Device **TC26x**
Marking/Step **ES-BC, BC**
Package **see Data Sheet**

This Errata Sheet describes the deviations from the current user documentation.

Figure 1 Message buffer transfer from Message RAM to OBF

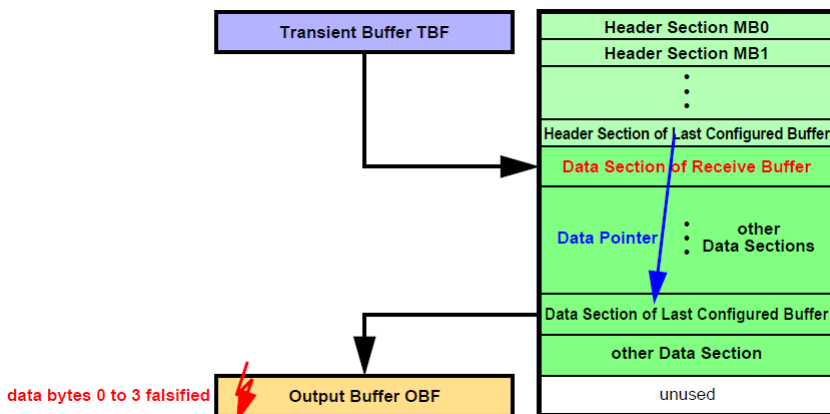
When the message buffer has its payload configured to maximum length (**PLC = 127**), the OBF word on address 00h (payload data bytes 0 to 3) is overwritten with unexpected data at the end of the transfer.

a) When a message is transferred from the Last Configured Buffer in the Message RAM to the OBF and **PLC** = 127 it may happen, that at the end of the transfer the OBF word on address 00h (payload data bytes 0 to 3) is overwritten with unexpected data (see **Figure 1**).

Figure 2 Message buffer transfer from IBF to Message RAM

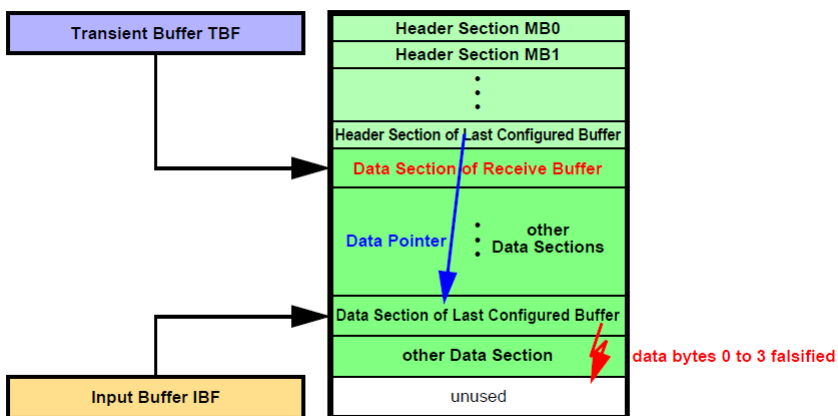
After the Data Section of the selected message buffer in the Message RAM has been written, one additional write access overwrites the following word in the Message RAM which might be the first word of the next Data Section.

b) When a message is transferred from IBF to the Last Configured Buffer in the Message RAM, it may happen, that at the end of the transfer of the Data Section one additional write access overwrites the following word, which may be the first word of another message's Data Section in the Message RAM (see **Figure 2**).

Figure 3 Message RAM Configurations

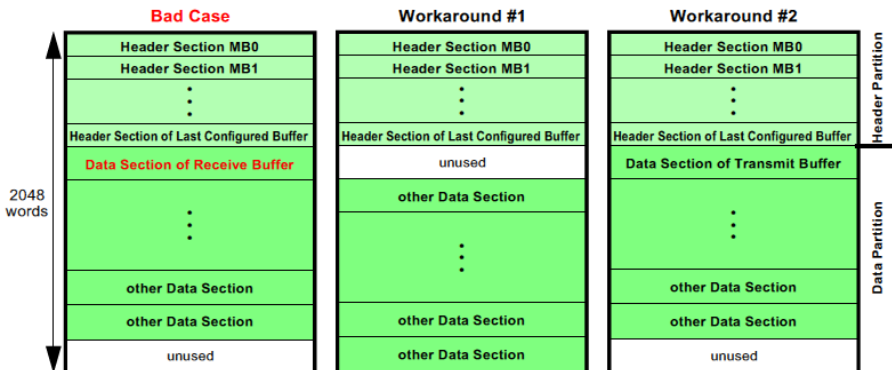
The erratum is limited to the case when (see **Figure 3** “Bad Case”):

2) Ensure that the Data Section directly following the Header Partition is assigned to a transmit buffer.

Figure 4 Example sequence showing how registers ETRRx may be filled with “Error Free” addresses

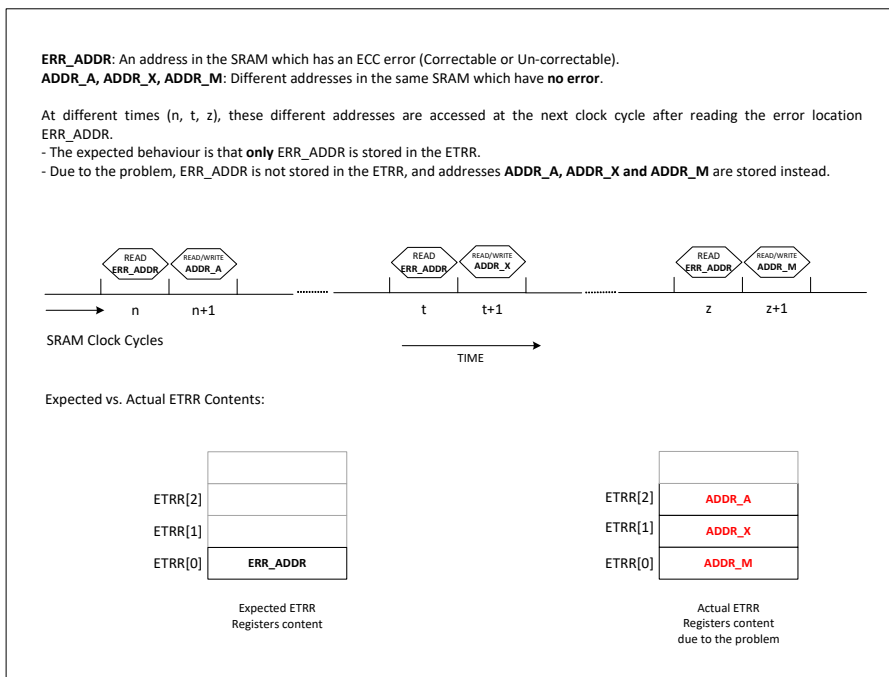
When such a consecutive access sequence (read from ERR_ADDR followed by read/write of different address(es)) happens multiple times, registers ETRRx are filled with addresses that have actually no error – and the SRAM address which actually has an error is not stored indeed. **Figure 4** shows such an example scenario.

The consequence of the scenario explained in **Figure 4** is that a single error in the SRAM – example just one correctable error at a location ERR_ADDR – can result in registers ETRRx getting filled with fault-free address, and thus potentially even triggering an ETRR overflow.

Figure 5 Recommended Software Handling - Flowchart

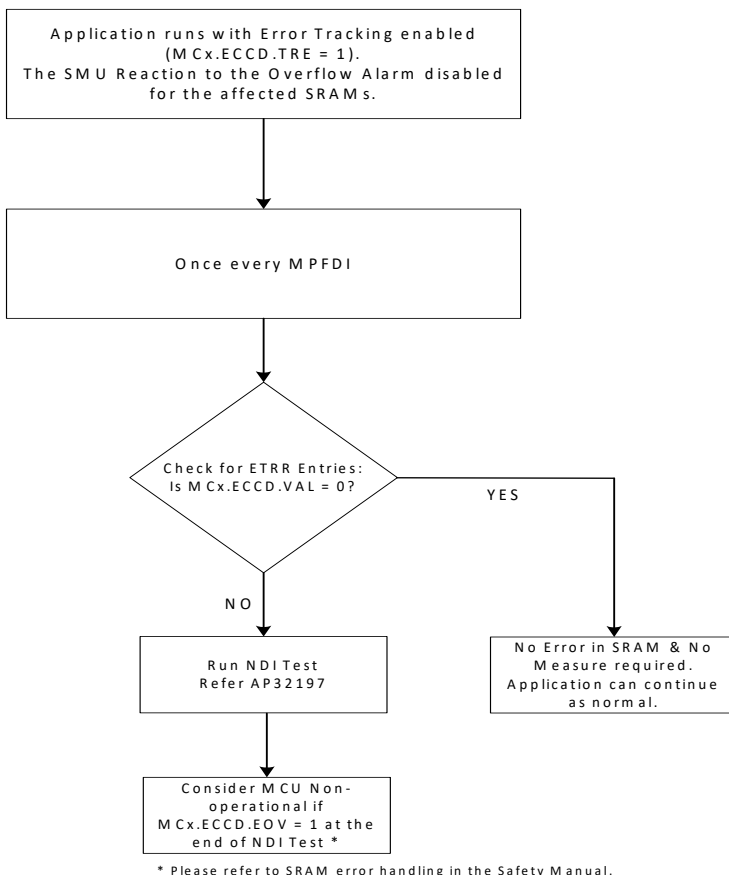
A flowchart of the recommended software handling is shown in [Figure 5](#).

If there is at least one valid ETRR entry (i.e. $MCx.ECCD.VAL \neq 0$) then the software shall run a Non-Destructive-Inversion (NDI) Test on the affected SRAM. Please refer to application note AP32197 (AURIX™ Memory tests using the MTU) for an example regarding running this test.

At the end of this test, if an ETRR overflow is detected ($MCx.ECCD.EOV = 1_B$) then the MCU shall be considered non-operational. Refer to section on Correctable SRAM Error handling in the Safety Manual.

Figure 9 Timing of LVDS TX interface command sending in relation to IRQ.IFCFS

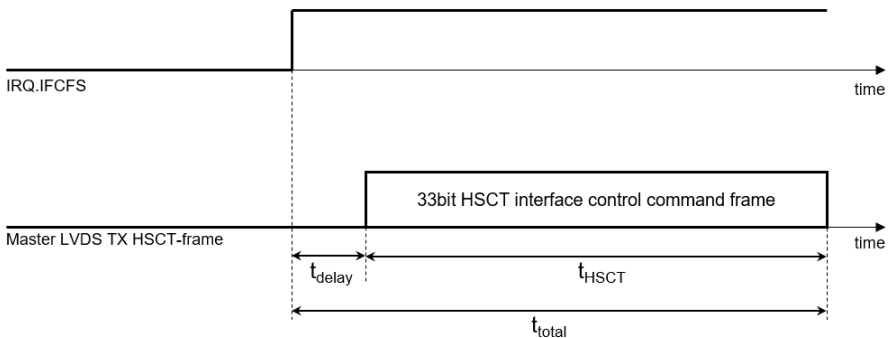
the user might falsely assume that also the actual sending on the LVDS TX port has already occurred once the IRQ.IFCFS flag is set, which is not true.

Instead the timing shown in **Figure 9** applies.

Figure 15 Package Outlines LQFP-144 for TC26x

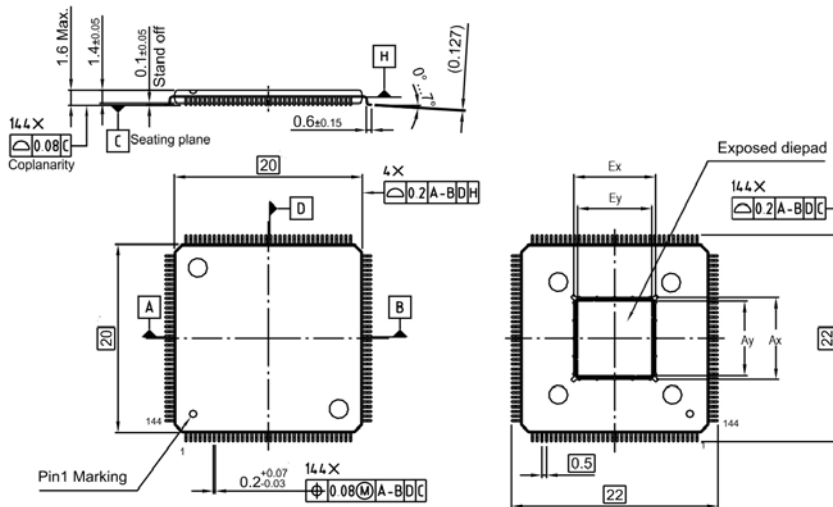
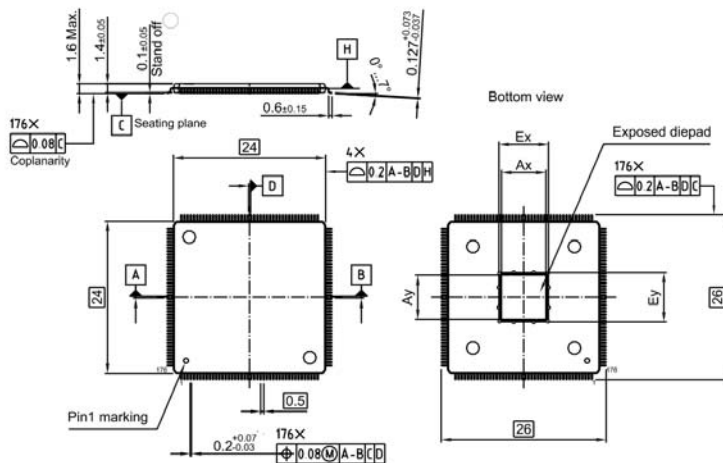
This information shall substitute the corresponding information in the TC26x Data Sheets (V1.1 2015-07 for step BB, V1.0 2017-06 for step BC).

Note: For the exposed diepad of the LQFP-144 package of the TC26x, structural corner protrusions have to be considered for purposes of system design and integration with a maximum boundary of 8.0 mm for TC26x devices with feature package D and DC (square Epad), and of 8.9 mm (in x direction) and 9.5 mm (in y direction) for TC26x devices with feature package DA.

Figure 19 SENT Tolerance of this Design Step

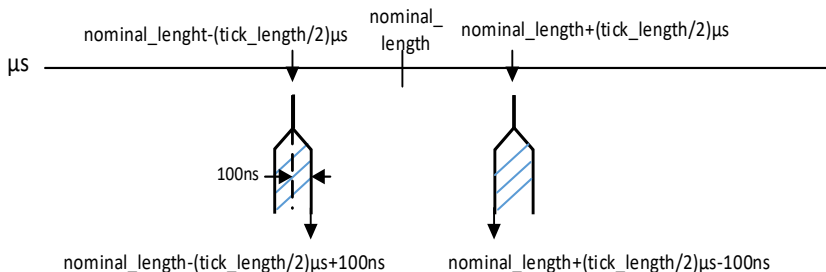
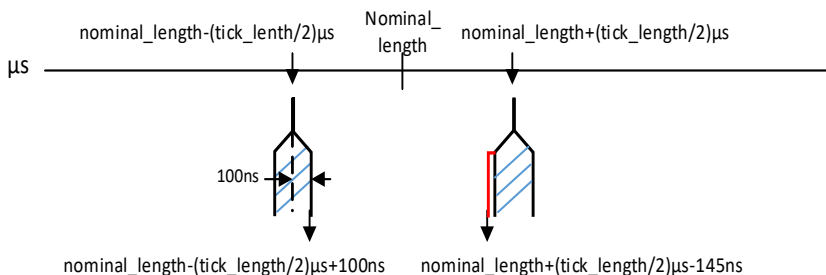
In this design step the range is delimited as follows:

- The lower border is $\text{nominal_value} - (\text{tick_length}/2) \mu\text{s} + 100 \text{ ns}$
- The upper border is $\text{nominal_value} + (\text{tick_length}/2) \mu\text{s} - 145 \text{ ns}$.

Figure 20 Short Serial Message, Serial Data Encoding over 16 messages

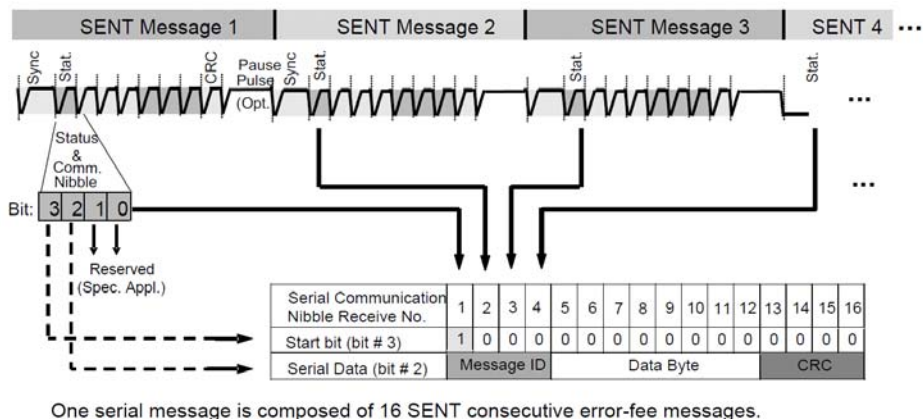
Correction

Figure 20 shows a corrected version of this figure.
